2. CD-1 Rezoning: 5589-5661 Baillie Street - Oppose

APPENDIX A

SECTION - EAST-WEST

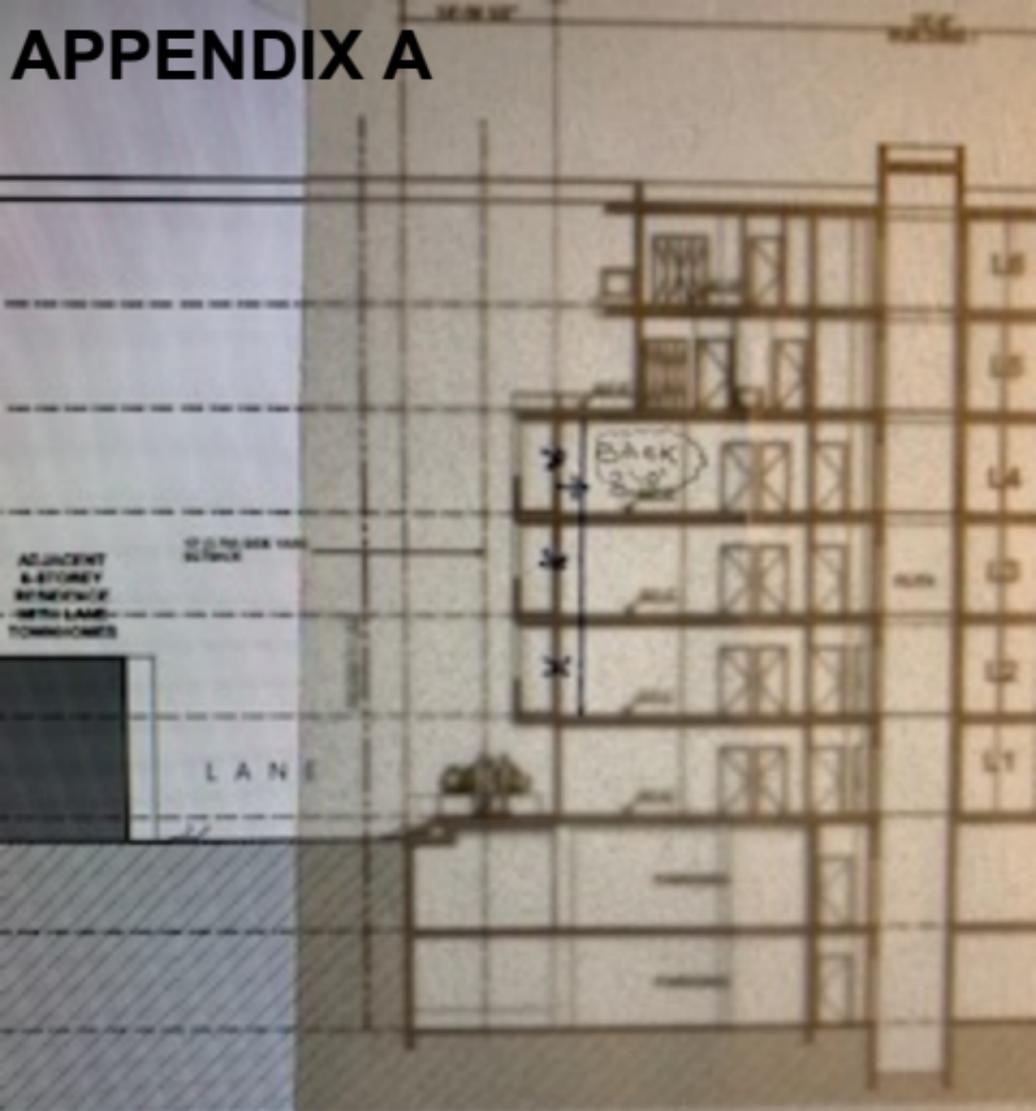
07/07/2022	12:28	PH2 - 2. CD-1 Rezoning: 5589-5661 Baillie Street	Oppose	1. Opposed the application with an amendment proposed as follows:- On the applicant section plan, the south exterior wall should set back additional 2'-0" (two feet) from the original plan. Starting from the 2nd floor to 4th floor. Please see the section drawing illustrated attached. The reason is to retain and provide the privacy for residence of Villa 3 and 4. The town houses across the lane. For the 2nd floor elevation on Villa 3 and 4 are 2'-0" to 3'-0" respectively lower than the new development 2nd floor elevation. 2. Opposed the application in regards to the providing only 76 vehicle parking spaces for 120 secured rental units. Now a day, even one owns a bicycle may own a car as well. In short there will be lots of Cars Park on the street. The street becomes parking strips. t creates an environment for the risk of car vandalism or car theft. If these crimes happened, it will cause unsafe on the street and unsafe to the neighborhood. This is a big concern.	Martin Zhn			Oakridge	Appendix A

07/07/2022	12:33	PH2 - 2. CD-1 Rezoning: 5589-5661 Baillie Street	Oppose	1. Opposed the application with an amendment proposed as follows:- On the applicant section plan, the south exterior wall should set back additional 2'-0" (two feet) from the original plan. Starting from the 2nd floor to 4th floor. Please see the section drawing illustrated attached. The reason is to retain and provide the privacy for residence of Villa 3 and 4. The town houses across the lane. For the 2nd floor elevation on Villa 3 and 4 are 2'-0" to 3'-0" respectively lower than the new development 2nd floor elevation. 2. Opposed the application in regards to the providing only 76 vehicle parking spaces for 120 secured rental units. Now a day, even one owns a bicycle may own a car as well. In short there will be lots of Cars Park on the street. The street becomes parking strips. t creates an environment for the risk of car vandalism or car theft. If these crimes happened, it will cause unsafe on the street and unsafe to the neighborhood. This is a big concern.	Yuen Ming May Lee			Oakridge	Appendix A

07/07/2022	13:44	PH2 - 2. CD-1 Rezoning: 5589-5661 Baillie Street	Oppose	1. Opposed the application with an amendment proposed as follows:- On the applicant section plan, the south exterior wall should set back additional 2'-0" (two feet) from the original plan. Starting from the 2nd floor to 4th floor. Please see the section drawing illustrated attached. The reason is to retain and provide the privacy for residence of Villa 3 and 4. The town houses across the lane. For the 2nd floor elevation on Villa 3 and 4 are 2'-0" to 3'-0" respectively lower than the new development 2nd floor elevation. 2. Opposed the application in regards to the providing only 76 vehicle parking spaces for 120 secured rental units. Now a day, even one owns a bicycle may own a car as well. In short there will be lots of Cars Park on the street. The street becomes parking strips. t creates an environment for the risk of car vandalism or car theft. If these crimes happened, it will cause unsafe on the street and unsafe to the neighborhood. This is a big concern.	May Lee			Oakridge	Appendix A

07/07/2022	16:43	PH2 - 2. CD-1 Rezoning: 5589-5661 Baillie Street	Oppose	1. Opposed the application with an amendment proposed as follows:- On the applicant section plan, the south exterior wall should set back additional 2'-0" (two feet) from the original plan. Starting from the 2nd floor to 4th floor. Please see the section drawing illustrated attached. The reason is to retain and provide the privacy for residence of Villa 3 and 4. The town houses across the lane. For the 2nd floor elevation on Villa 3 and 4 are 2'-0" to 3'-0" respectively lower than the new development 2nd floor elevation. 2. Opposed the application in regards to the providing only 76 vehicle parking spaces for 120 secured rental units. Now a day, even one owns a bicycle may own a car as well. In short there will be lots of Cars Park on the street. The street becomes parking strips. t creates an environment for the risk of car vandalism or car theft. If these crimes happened, it will cause unsafe on the street and unsafe to the neighborhood. This is a big concern.	Ping Liu			Unknown	Appendix A

07/07/2022	16:48	PH2 - 2. CD-1 Rezoning: 5589- 5661 Baillie Street	Oppose	1. Opposed the application with an amendment proposed as follows:- On the applicant section plan, the south exterior wall should set back additional 2'-0" (two feet) from the original plan. Starting from the 2nd floor to 4th floor. Please see the section drawing illustrated attached. The reason is to retain and provide the privacy for residence of Villa 3 and 4. The town houses across the lane. For the 2nd floor elevation on Villa 3 and 4 are 2'-0" to 3'-0" respectively lower than the new development 2nd floor elevation. 2. Opposed the application in regards to the providing only 76 vehicle parking spaces for 120 secured rental units. Now a day, even one owns a bicycle may own a car as well. In short there will be lots of Cars Park on the street. The street becomes parking strips. t creates an environment for the risk of car vandalism or car theft. If these crimes happened, it will cause unsafe on the street and unsafe to the neighborhood. This is a big concern.	Qi Zhang		s.22(1) Personal and Confidential	Unknown	Appendix A

07/07/2022	16:52	PH2 - 2. CD-1 Rezoning: 5589- 5661 Baillie Street	Oppose	1. Opposed the application with an amendment proposed as follows:- On the applicant section plan, the south exterior wall should set back additional 2'-0" (two feet) from the original plan. Starting from the 2nd floor to 4th floor. Please see the section drawing illustrated attached. The reason is to retain and provide the privacy for residence of Villa 3 and 4. The town houses across the lane. For the 2nd floor elevation on Villa 3 and 4 are 2'-0" to 3'-0" respectively lower than the new development 2nd floor elevation. 2. Opposed the application in regards to the providing only 76 vehicle parking spaces for 120 secured rental units. Now a day, even one owns a bicycle may own a car as well. In short there will be lots of Cars Park on the street. The street becomes parking strips. t creates an environment for the risk of car vandalism or car theft. If these crimes happened, it will cause unsafe on the street and unsafe to the neighborhood. This is a big concern.	Yang Chen			Oakridge	Appendix A

07/07/2022	16:55	PH2 - 2. CD-1 Rezoning: 5589- 5661 Baillie Street	Oppose	1. Opposed the application with an amendment proposed as follows:- On the applicant section plan, the south exterior wall should set back additional 2'-0" (two feet) from the original plan. Starting from the 2nd floor to 4th floor. Please see the section drawing illustrated attached. The reason is to retain and provide the privacy for residence of Villa 3 and 4. The town houses across the lane. For the 2nd floor elevation on Villa 3 and 4 are 2'-0" to 3'-0" respectively lower than the new development 2nd floor elevation. 2. Opposed the application in regards to the providing only 76 vehicle parking spaces for 120 secured rental units. Now a day, even one owns a bicycle may own a car as well. In short there will be lots of Cars Park on the street. The street becomes parking strips. t creates an environment for the risk of car vandalism or car theft. If these crimes happened, it will cause unsafe on the street and unsafe to the neighborhood. This is a big concern.	Jinying Sun			Oakridge	Appendix A

07/07/2022	16:58	PH2 - 2. CD-1 Rezoning: 5589- 5661 Baillie Street	Oppose	1. Opposed the application with an amendment proposed as follows:- On the applicant section plan, the south exterior wall should set back additional 2'-0" (two feet) from the original plan. Starting from the 2nd floor to 4th floor. Please see the section drawing illustrated attached. The reason is to retain and provide the privacy for residence of Villa 3 and 4. The town houses across the lane. For the 2nd floor elevation on Villa 3 and 4 are 2'-0" to 3'-0" respectively lower than the new development 2nd floor elevation. 2. Opposed the application in regards to the providing only 76 vehicle parking spaces for 120 secured rental units. Now a day, even one owns a bicycle may own a car as well. In short there will be lots of Cars Park on the street. The street becomes parking strips. t creates an environment for the risk of car vandalism or car theft. If these crimes happened, it will cause unsafe on the street and unsafe to the neighborhood. This is a big concern.	HuanYu Zhang			Oakridge	Appendix A
